# Planning Report

## Tuller Flats Residential Development

Agenda Item	1
Case Number	13-121INF
Proposal	A multi-family residential development consisting of 392 apartment units within 30 three-story apartment buildings, a clubhouse/community center, and associated streets and open spaces on approximately 17 acres.
Request	Informal review and non-binding feedback.
Site Location	South side of Tuller Road, approximately 700 feet east of Tuller Ridge Drive.
Applicant	Casto, represented by Aaron Underill, Esq., Underhill Law Office LLC
Case Manager	Justin Goodwin, AICP, Planner II   (614) 410-4677   <a href="mailto:jgoodwin@dublin.oh.us">jgoodwin@dublin.oh.us</a>
Planning Recommendation	<b>Discussion and Feedback</b>

13-121INF  
Informal Review  
Tuller Flats  
4313 Tuller Road

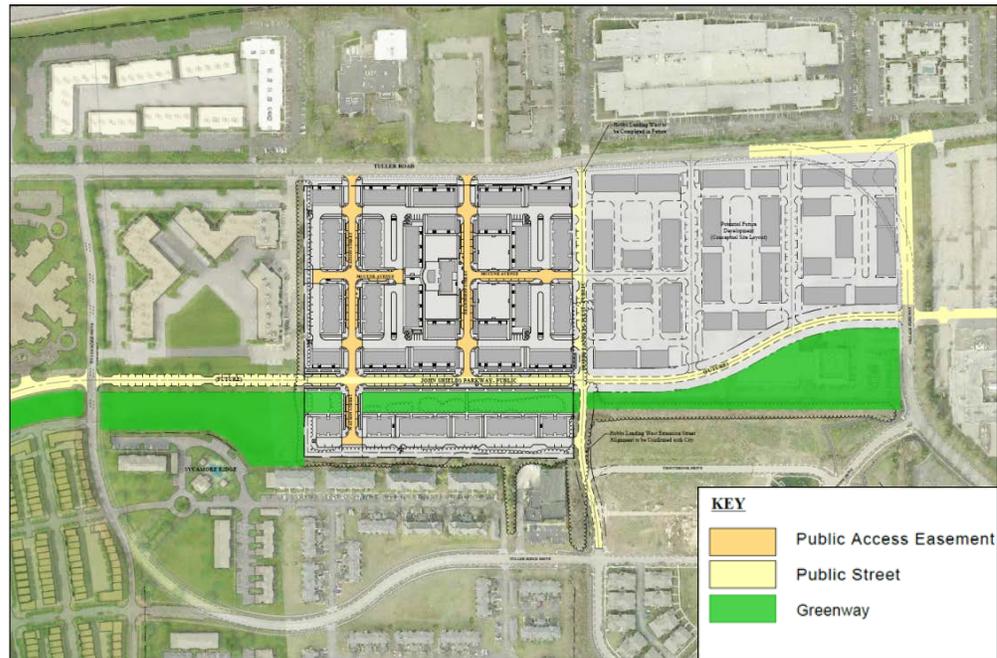
Sheet 2 of the Informal Plan set depicts the proposed site within the surrounding development context, showing:

- Existing development in the Bridge Street District east of the Scioto River;
- The conceptual street network as generally depicted in the Bridge Street Zoning Code provisions and Community Plan;
- The Vnable Skilled Nursing development (under construction) west of Tuller Ridge Drive;
- The conceptual Bridge Park Mixed-Use Development (Crawford Hoying Development Partners) east of Riverside Drive, as presented to the Commission as part of an Informal Review application on November 14, 2013; and
- A continuous greenway connection through the proposed site, linking Riverside Drive and the planned riverside park to Village Parkway, generally as depicted in the Bridge Street District Plan (Community Plan).

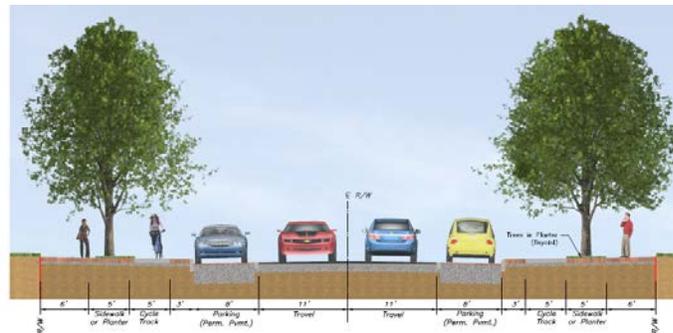
Sheet 5 of the proposed plans provides a more detailed view of the proposed site as it relates to adjacent properties. This sheet also depicts a conceptual site layout for the adjacent  $\pm 18$  acres of land located immediately to the east of the site. The applicant has indicated that it may pursue subsequent phases of development in this location, with an intent to develop additional residential apartment buildings.

The adjacent development site includes the existing Byers Auto property, through which the John Shields Parkway extension is planned. The intersection with Village Parkway is coordinated with the planned extension of John Shields Parkway through the Dublin Village Center. This plan also depicts the reconfiguration of the Tuller Road/Village Parkway intersection as a traditional 'T' intersection.

The context plan shows the extension of Hobbs Landing Drive from the Greystone Mews development (M/I Homes) to John Shields Parkway, which has been discussed with M/I. The plans also show Hobbs Landing Drive extending north to Tuller Road as part of a future development phase. This street extension is necessary to provide street frontage and vehicular access for buildings on the east edge of the current development proposal; the east boundary of the current  $\pm 17$ -acre site will serve as the west right-of-way line for the future street.

The proposed plans also depict the extension of John Shields Parkway to the west through land currently owned by the City (Sycamore Ridge Park). This alignment coordinates with the alignment of John Shields Parkway west of Tuller Ridge Drive, which will provide street frontage and vehicular access to the Vrable Skilled Nursing Facility. The remainder of the City-owned parkland will be integrated into the planned greenway.

John Shields Parkway

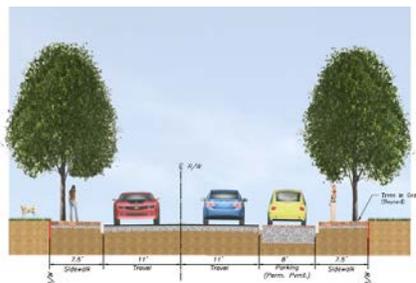
The street sections for John Shields Parkway, Watson Street and Deardorff Streets are consistent with typical sections the City has developed for Corridor Connector Streets and Neighborhood Streets in the Bridge Street District. During the Pre-Application Review, Planning and Engineering recommended the introduction of an east/west Neighborhood Street through the site, and suggested it be designed as a 'yield street' based on expected low volumes of local traffic. The applicant has incorporated McCune Avenue in response. The proposed section for McCune Avenue will require additional analysis by Planning and Engineering to determine appropriate dimensions for all street elements.

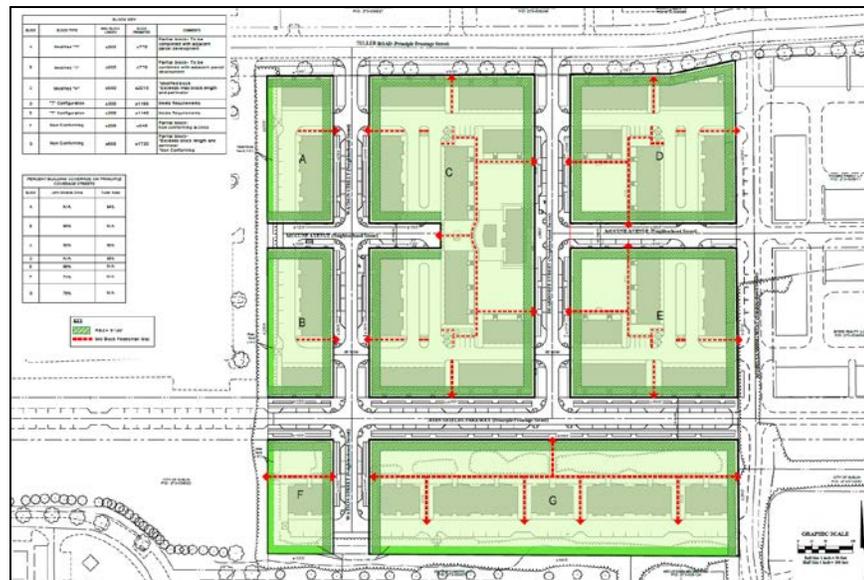
Section 153.061 designates both John Shields Parkway and Tuller Road as a PFS. Driveway or alley access points are not permitted from a PFS if practical alternatives exist. The proposed plan appropriately provides block access with private alley connections to the proposed neighborhood streets.

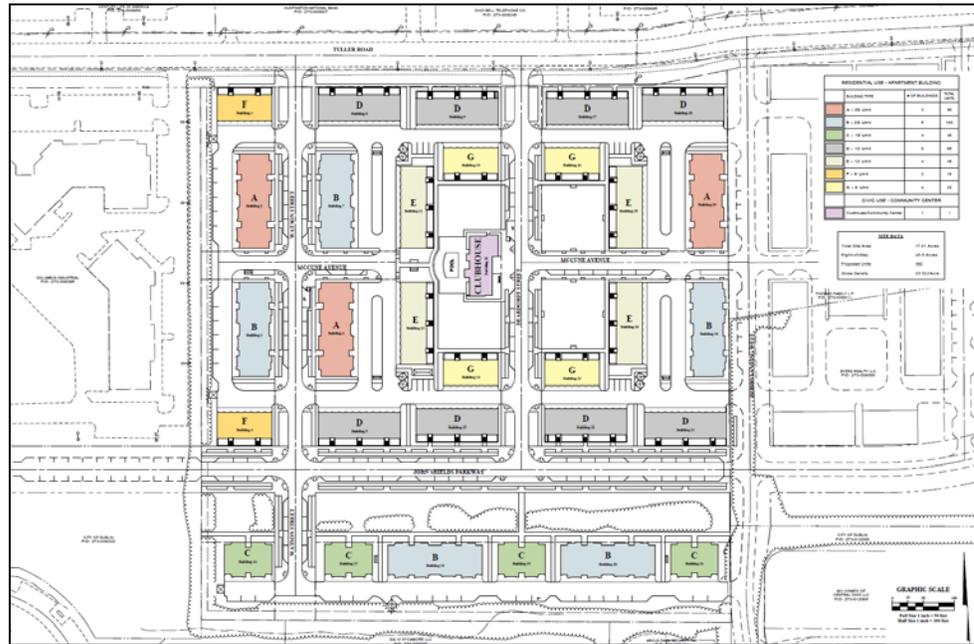
<p><b>Proposed Building Types and Architecture</b></p>	<p>A Building Type Plan is provided on Sheet 7, showing the location of proposed buildings as illustrated in architectural renderings on Sheets A through G (Apartment Buildings) and CH (Clubhouse). Perspective renderings (Sheets V.1 through V.5) illustrate the proposed architectural character with views from streets and open spaces throughout the development. Planning has not conducted an in-depth analysis of the individual building type requirements for the proposed buildings; this will occur with the Basic Site Plan and Site Plan Review process.</p> <p>The plan proposes 30 multiple family residential buildings, all of which are considered Apartment Building Types per the Bridge Street District zoning regulations. The plan includes a series of 8-, 10-, 12-, and 20-unit apartment buildings. Proposed renderings show a contemporary architectural style emphasizing geometric forms, with flat roofs (or parapets emulating a flat roof appearance). Illustrated building materials include brick, cementitious siding and cementitious panels.</p>

During the Pre-Application Review, the ART noted a lack of architectural variety with the proposal. The applicant has responded with an additional building model and has included options that depict material and color variations for each model. However, the architectural form and style remains uniform across all models.
